**EXAMINATION OF THE STROUD DISTRICT LOCAL PLAN REVIEW:  
INSPECTORS' MATTERS, ISSUES AND QUESTIONS**

## **Stroud District Council Local Plan Funding Delivery Plan Technical Note - National Highways Review**

Figure 4-2 Option 4, upgrade of J12 to a Gyratory Junction

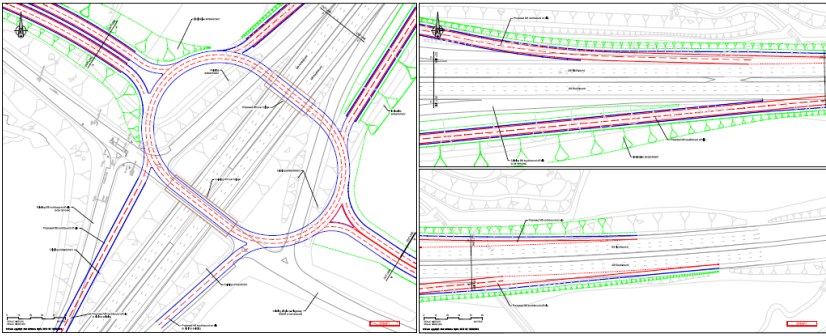
Due to site constraints and development to the east of the junction, Option 4 in the Jacobs report in the illustration below appears oversimplified for a grade separated gyratory by repurposing the existing structure.

The alterations to the exiting pavement, possibly the wingwalls, new entry / exit slips to the south, associated earthworks / drainage, prolonged programme, the impact the site constraints pose to the phasing, additional traffic management requirements and productivity, it is advised that this estimate is inadequate before additional management fees, a scheme of this type size would attract due the complexity, are considered.

Non-recoverable VAT (NRVAT) is payable for a new structure, but not for the alteration of an existing structure. To accurately calculate the full value of NRVAT more information would be needed.

Schematic layout with proposed overlayed to existing SRN

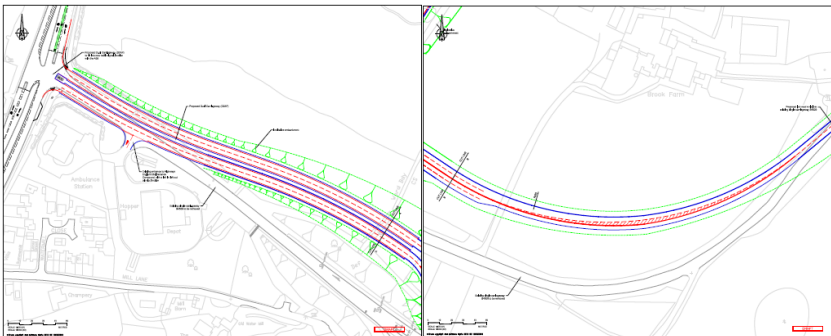
SDC propose that the existing bridge is retained and to the north a new bridge would be constructed to form a gyratory interchange. The existing single carriageway (B4509) between the bridge and the A38, would be replaced by a realigned new dual carriageway with signalised junction that would require land acquisition. Similarly, to the east an offline new road is required, across third party land, and would be single carriageway transitioning to a dual carriageway to tie into the proposed gyratory. In addition to the link roads the NB & SB Entry / Exit slips would need significant realignment and construction. At this early stage it is difficult to quantify the magnitude of the earthworks, drainage, or any diversion of existing services.

The proposed mitigation is significantly greater than the proposed J12 works.

The deck is planned to be refurbished in year 1 (25/26) of Road Investment Strategy 3 (RIS3). The NH Structures Engineering Team Manager has advised retention of this overbridge as part of the improvement would be uneconomical due to it nearing the end of its design life and the cost to maintain and repair the structure in future years.
